Project
Site
Phase 5 ENT Treatment Centre
Phase 5

Document Title
External Doors and Louvres
Roller Shutter

File Name
Project Originator Vol. Level Type Role Number
P5 - BMJ-001-00-DR-A-3605

Revision Code Issued for
P05

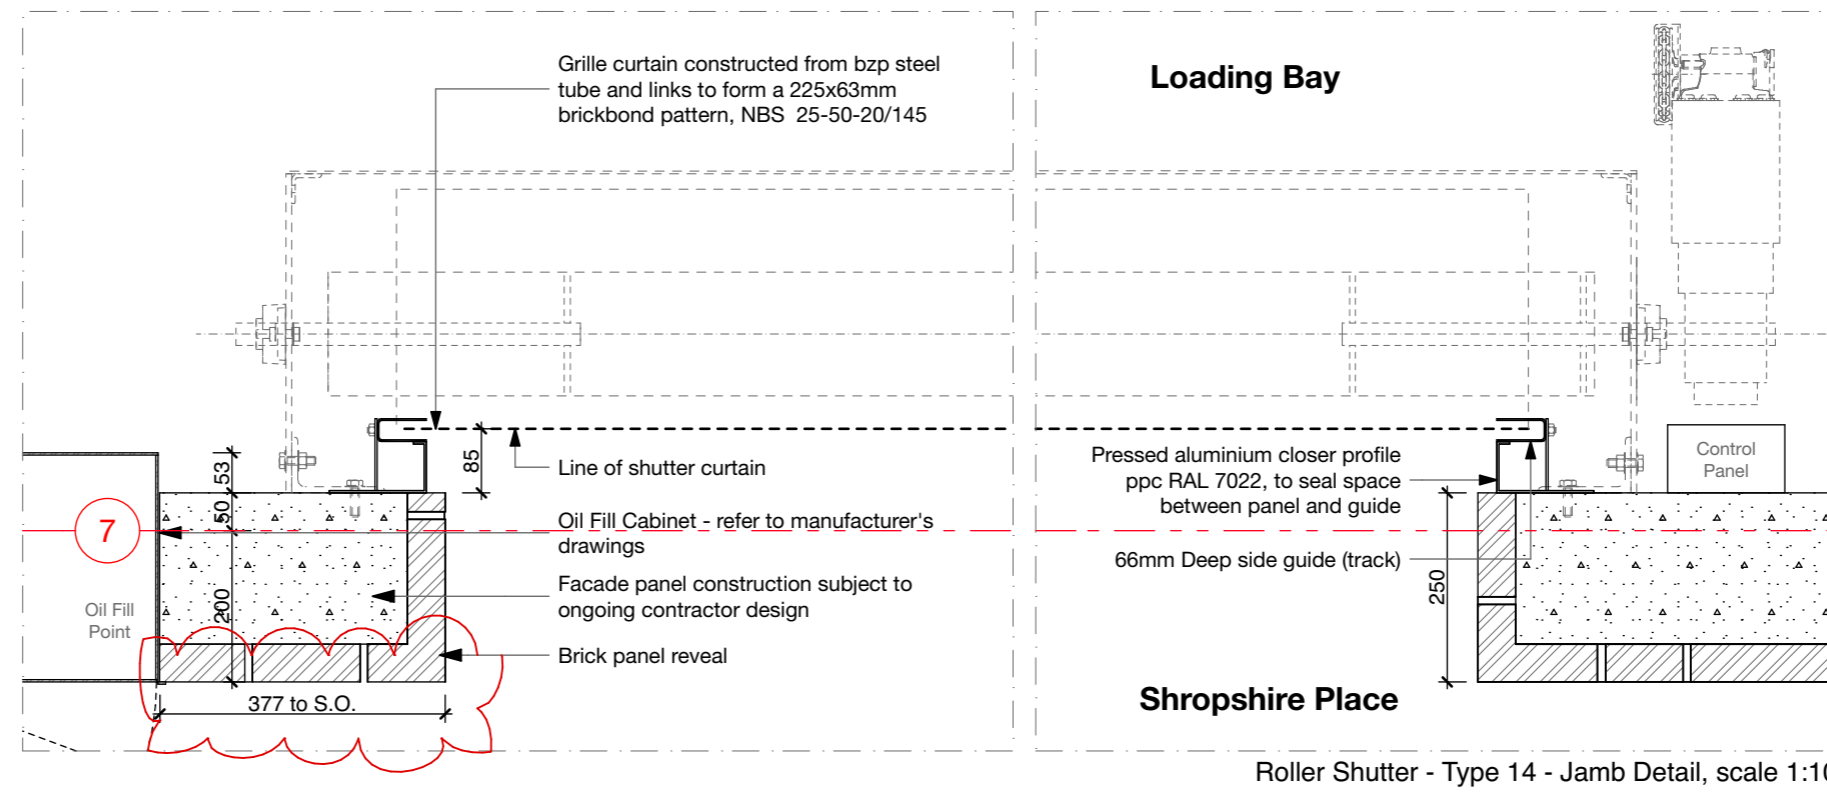
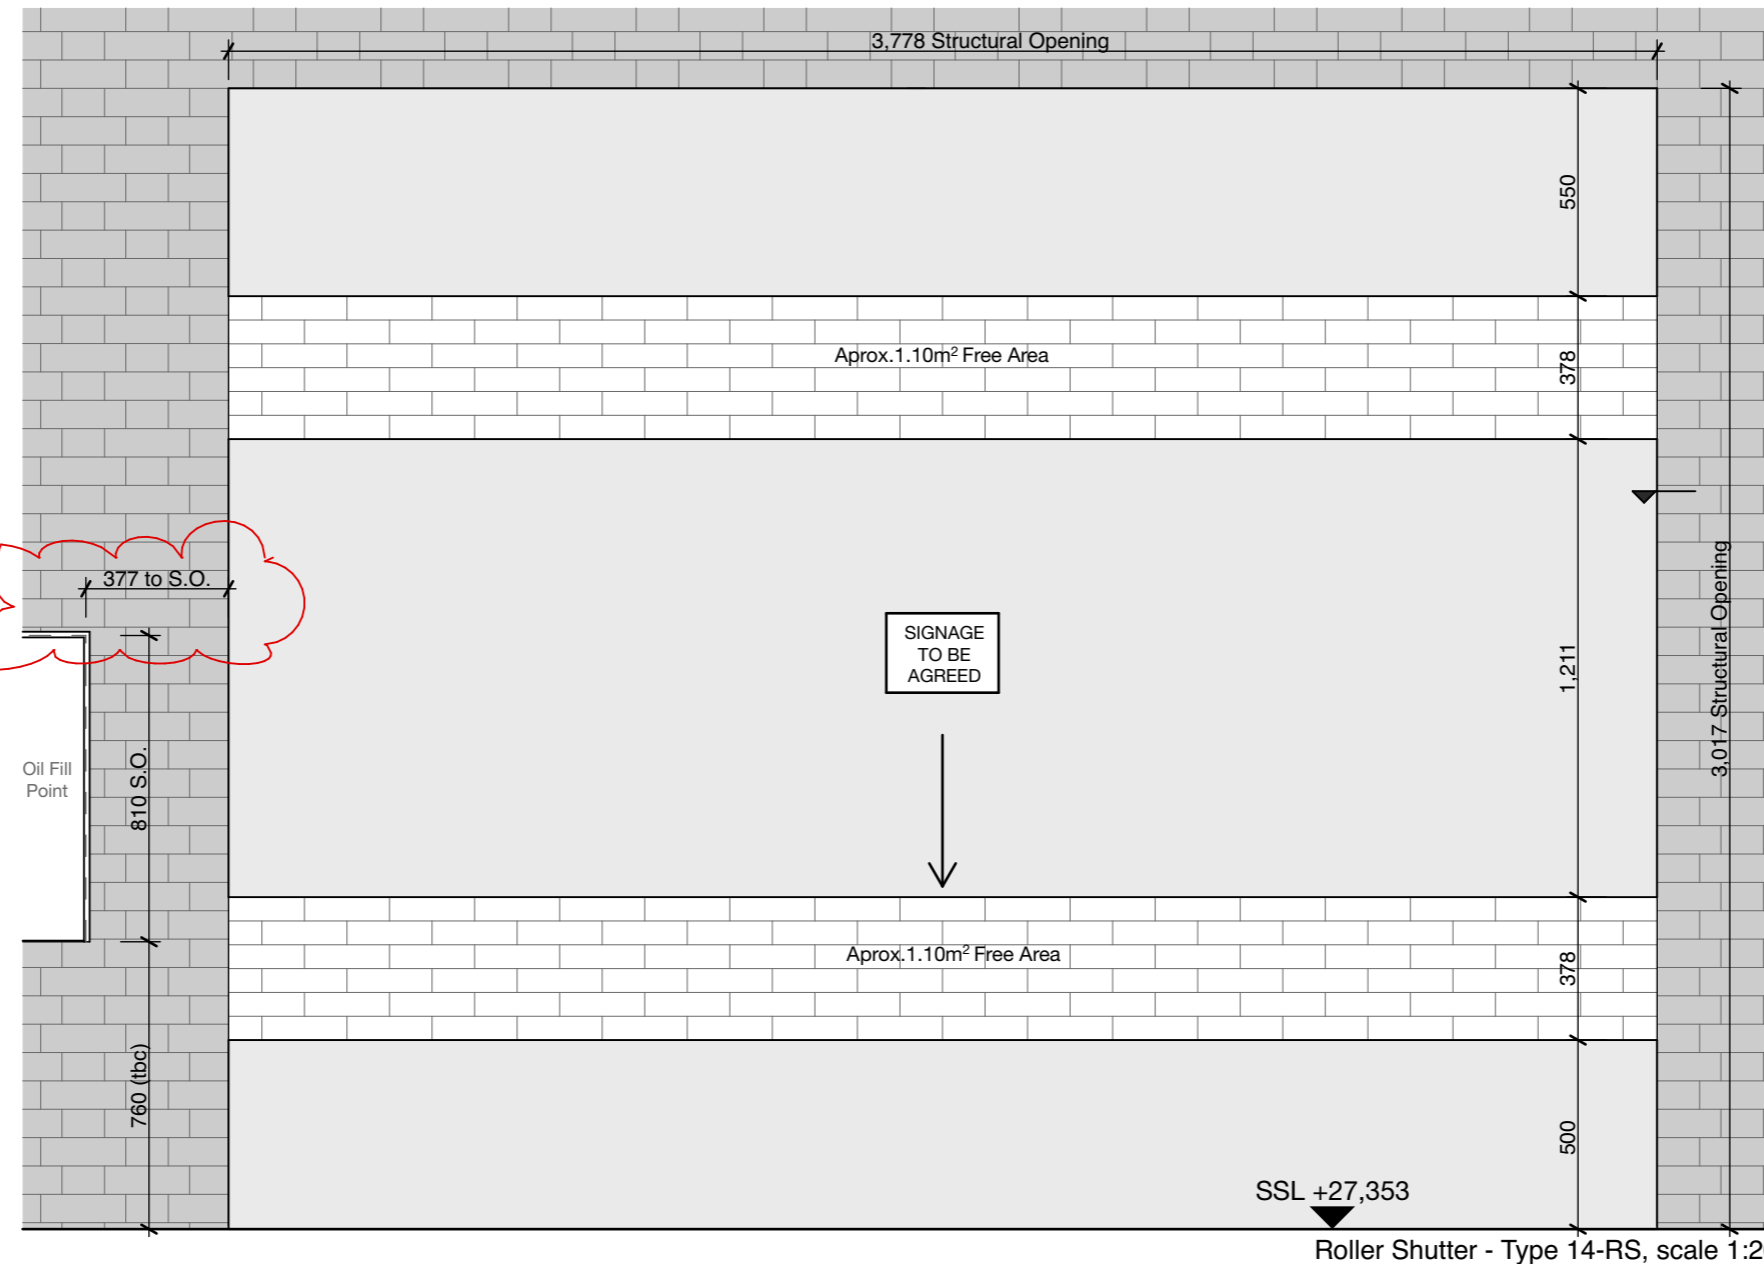
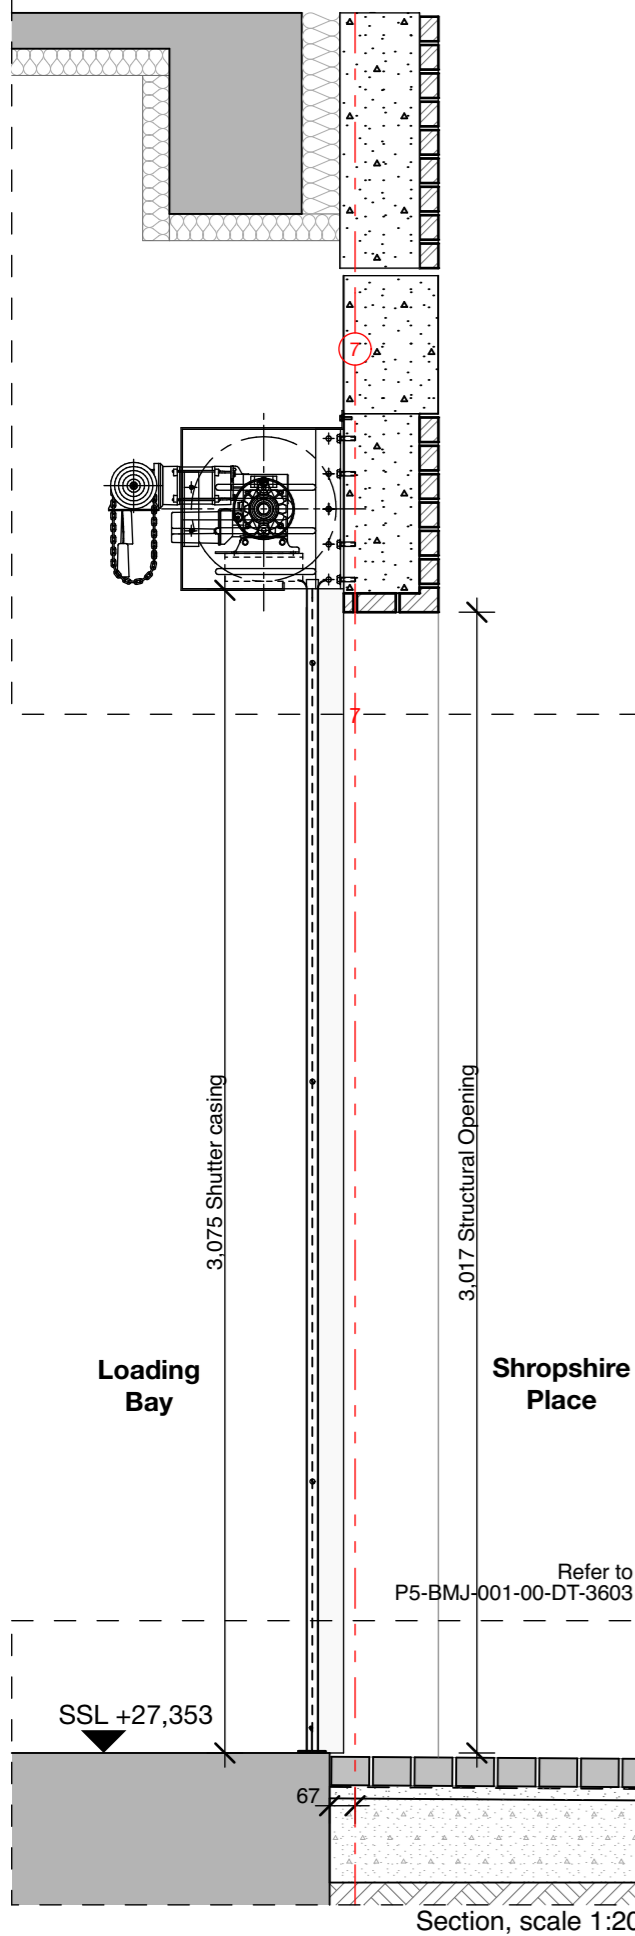
| Issued as S4. / Oil Fill cabinet centralized within Techrete panel. AV | MM | MH | HG | 25/04/2018 |
| P05 Intercom and Card Reader centralized between Structural Opening and Oil Cabinet. | | | | |
| Concrete threshold removed. / Issued as S4. / Location/dimensions of Oil Cabinet clarified. / External paving build-up information added. | MM | MH | HG | 19/04/2018 |
| Concrete threshold added. / Issued as S4. / Roller shutter's motor changed to opposite side of the structural opening. / Control panel added. | MM | MH | HG | 07/03/2018 |
| Issued at this date as S3. / Roller shutter changed to directly fixed to back of Techrete panel. / Structural opening size revised. Gate changed to solid/wire mesh. / Size of structural opening revised. | MM | MH | HG | 07/02/2018 |
